71-9253

Department of Energy

**Responses to NRC Request for Additional Information
April 4, 2001**

CONFIGURATION 1 - "-85" DESIGNATION

Figure 1
Location and Geometry of Aluminum Spacer Sleeve

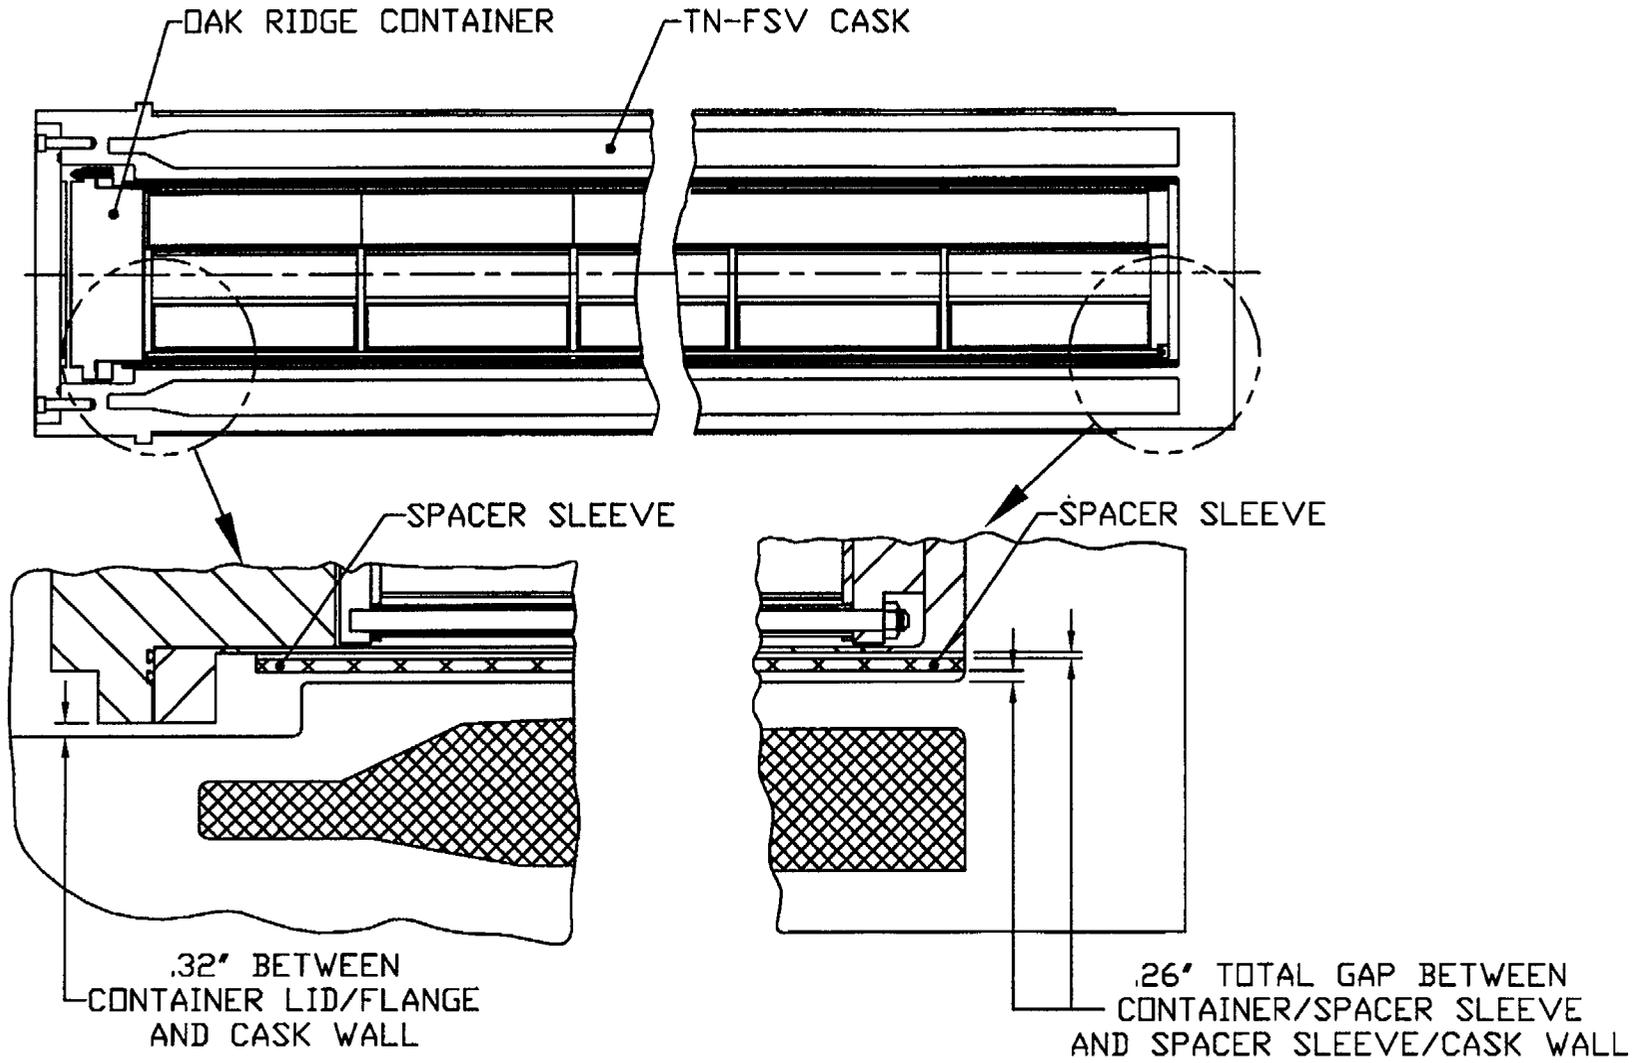
- 2-9 Describe the function of the spacer sleeve (Item No. 30 in the Parts List on Drawing No. 3044-70-1) and the method of attachment to the Oak Ridge Container, if any.

Drawing No. 3044-70-1, Rev.0, shows the spacer sleeve on the outside of the container. The function of the sleeve and the method of attachment to the container shell are not addressed in the application or the packaging drawings. This information addresses the requirements of 10 CFR 71.33.

Figure 1 depicts the location and geometry of the aluminum spacer sleeve. The 0.32 in. gap between the container lid and the TN-FSV Cask wall inner surface, as well as the 0.26 in. gap between the aluminum spacer sleeve and the cask wall inner surface are clearly shown.

Figure 2.11.1-1
Free Body Diagram of Oak Ridge Container
Subjected to a Vertical or Near Vertical Lid End Drop

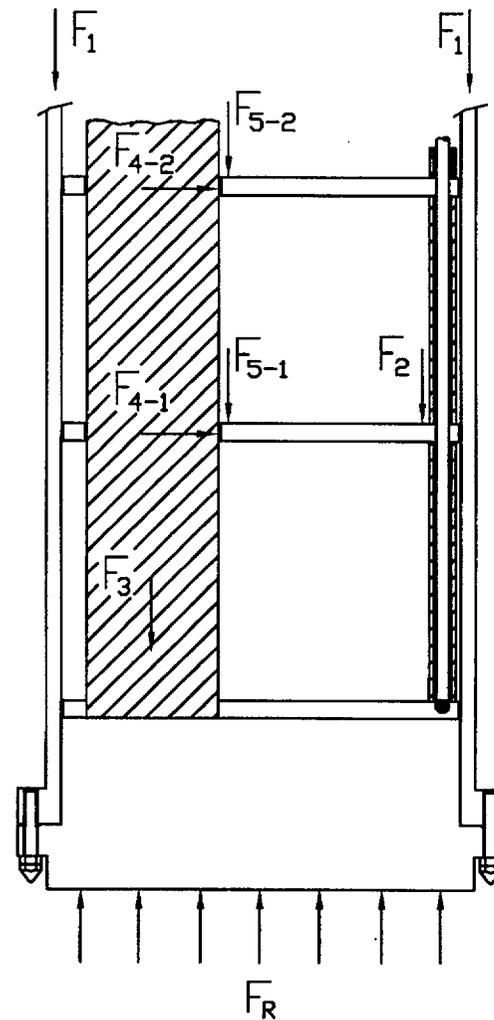
2-1 Revise the analysis for the standoffs to consider the weight of the canisters and the fuel assemblies.

Section 2.11.1.2A evaluates the structural adequacy of the standoffs for normal and accident condition events described 10 CFR Part 71. For computing the stresses in standoffs, self-weight, and the weights of poison plates, poison enclosures, and support discs, are used in calculating inertia loads during an end drop accident. However, the weight of the canisters and the spent fuel is not considered. Even though this assumption may be applicable for a perfectly vertical end drop, it will not be correct for a potential drop at any other angle. The inertial loads from the canisters should be considered in the analysis of the standoffs due to an end drop accident. Alternatively, justify why the weight of the canisters and fuel assemblies is not considered in this evaluation. This information addresses the requirements of 10 CFR 71.33.

- 2-4 Revise Section 2.11.1.2 of the application to justify using the number of poison enclosures and support discs as 8 instead of 9, and the weight of the poison enclosures as a standard 272 lbs. instead of 285 lbs. for the structural evaluation of the standoffs under an end drop accident.

The calculation for the compressive loads on the standoffs during an end drop accident in Section 2.11.1.2 considers the weights of various components, but does not explain the rationale for the numbers. This information addresses the requirements of 10 CFR 71.33.

During the vertical lid end drop (see Figure 2.11.1-1), the support disc and poison enclosure (including poison plates within the enclosure) nearest to the impact bear directly on the inner surface of the container lid for the lid end drop (or inner surface of the container bottom plate for the bottom end drop – see Figure 2.11.1-2). The standoffs do not carry this inertial load. Therefore, for the end drop analysis, the inertial loads of the support disc and poison enclosure with poison plates nearest to the impact, are not included in the axial compressive load applied to the standoffs.

Free body diagrams of the lid and bottom end drops, shown in Figures 2.11.1-1 and 2.11.1-2, clearly show that the support disc nearest to the impact is directly supported by the container lid/bottom plate, which is in turn supported by the TN-FSV Cask lid/ bottom plate.

Figure 2.11.1-2
Free Body Diagram of Oak Ridge Container
Subjected to a Vertical or Near Vertical Bottom End Drop

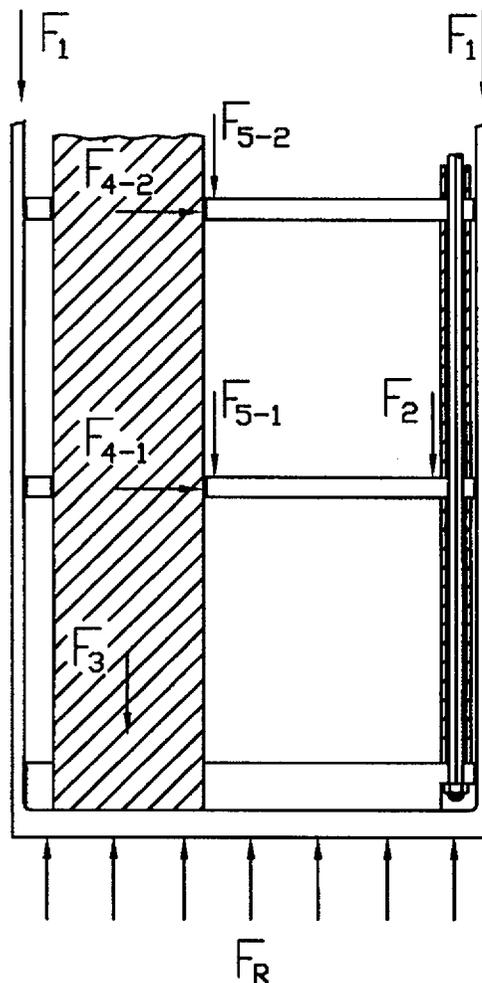
- 2-6 Revise the analysis of stresses in the Oak Ridge Container shell and top and bottom plates to include the weight of the canisters and spent fuel due to an end drop accident, as shown in Section 2.11.2.2 (pages 2.11.2-3 and 2.11.2-8) of the application.

A free body diagram of the bottom end drop, Figure 2.11.1-2, has been added to the Addendum. The reaction force, F_R , shown in Figure 2.11.1-2 represents the uniform support provided by the TN-FSV Cask bottom plate. The inertial load, F_1 , which represents the inertial loads of the Oak Ridge Container shell, flange, and lid, is used to calculate the maximum compressive stress in the Oak Ridge Container shell during the bottom end drop.

Figure 2.11.1-3
Free Body Diagram of Oak Ridge Container Fuel Basket
Subjected to a Side Drop

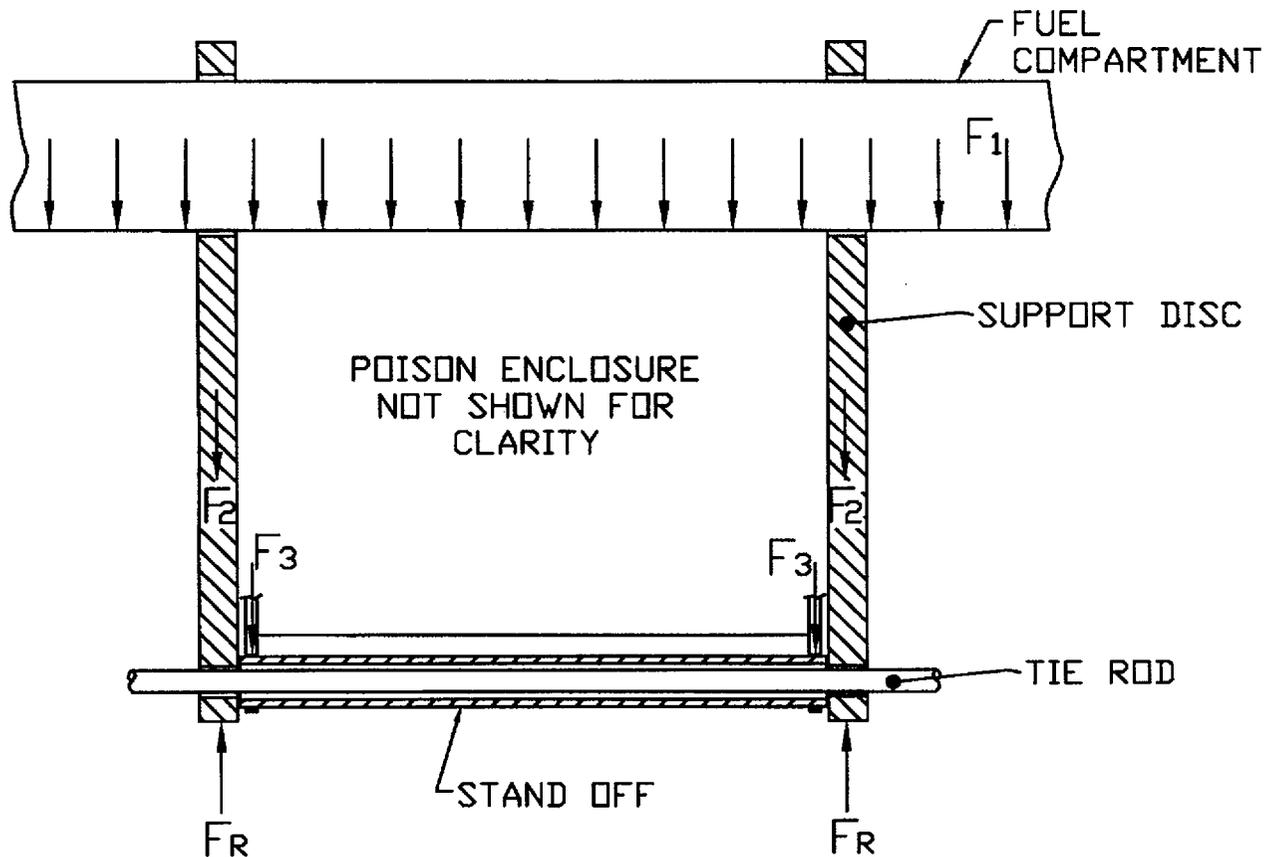
- 2-2 Revise the analysis of the standoffs to include consideration of a 30-foot side drop.

Section 2.11.1.2A evaluates the structural adequacy of the standoffs. This section addresses the load on the standoffs during an end drop accident, but does not address the behavior during a side drop accident. Alternatively, justify why the side drop accident was not considered. This information addresses the requirements of 10 CFR 71.33.

- 2-3 Revise the analysis of the side drop accident to consider bending stresses in the tie rods.

Section 2.11.1.2F evaluates the structural adequacy of the tie rods. This section addresses the loads on the tie rods during a side drop accident, and considers the shear stresses at the support discs. However, the bending stresses in the tie rods are not addressed. Alternatively, justify why the bending stresses in the tie rods are not considered for the side drop accident. This information addresses the requirements of 10 CFR 71.33.

During a side drop event, the standoffs and tie rods are subjected to their own inertial load plus the inertial load of the poison enclosures and poison plates (see Figure 2.11.1-3). The tie rods are supported by the transverse reaction force of the spacer discs. This reaction force generates shear stresses in the tie rods at the spacer disc locations, and bending stresses in both the tie rods and standoffs between the spacer discs. Consequently, shear stress generated in the standoffs, during a side drop event, is negligible. Bending stress in both the standoffs and the tie rods is computed in the tie rod analysis section below (see Response to question 2-3).

Figure 2.11.1-3 is a free body diagram of the fuel basket during a side drop event. The figure shows that the only loads applied to the tie rods are the inertial load of the poison enclosures, F_3 (acting near the support disc locations), and the inertial loads of the standoffs and tie rods themselves.

Figure 2.11.1-4
Free Body Diagram of Oak Ridge Container
Flux Trap Subjected to a Lid End Drop

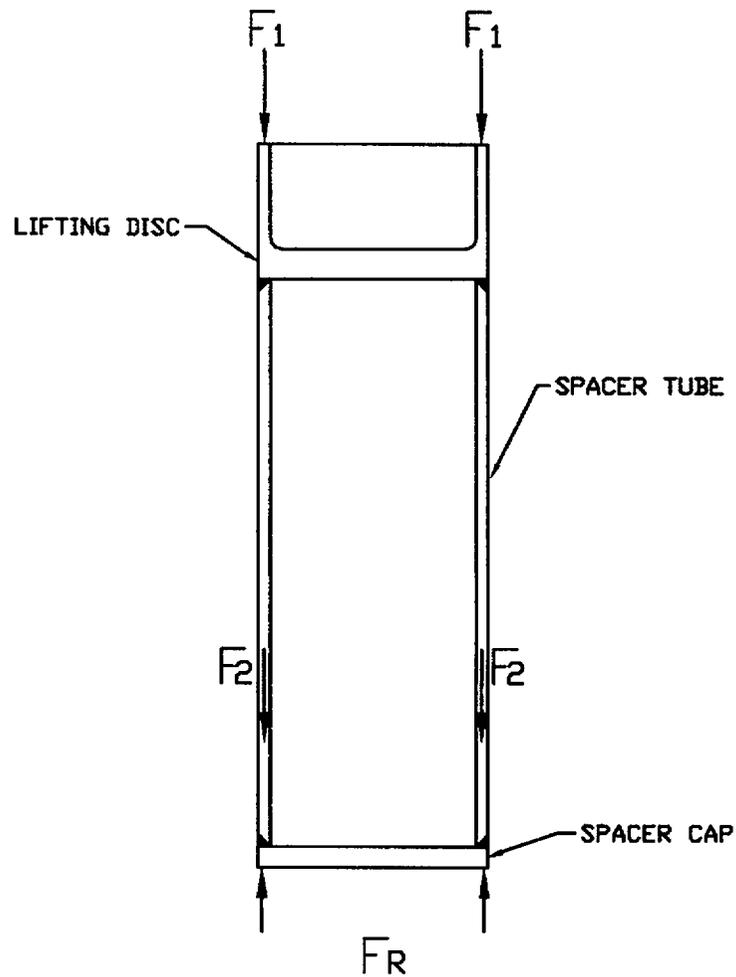
- 2-10 Revise the structural analysis to address the adequacy of the top and bottom plates of the flux trap for normal and accident condition events (10 CFR 71.71 and 10 CFR 71.73).

The flux traps are loaded in the Oak Ridge Container fuel compartments between Oak Ridge Canisters. The geometry of the flux trap lifting disc (top plate) and the Oak Ridge Canister handling head are very similar. The Oak Ridge Canister Head only provides support along the outer edge of the spacer cap (bottom plate) of the flux trap (see Figure 2.11.1-4). Therefore, during an end drop, the only load applied to the flux trap bottom and top plates is that generated by their own inertial load plus the inertial loads of the flux trap poison plates (item 24E, TN drawing no. 3044-70-3) and poison plate caps (item 24G). Since the flux trap bottom plate is thinner (0.45 in.) than the flux trap top plate (0.667 in.), the bending stresses generated in the bottom plate are greater than the bending stresses generated in the top plate.

The analysis is added to the flux trap spacer section of Appendix 2.11.1 in the Addendum.
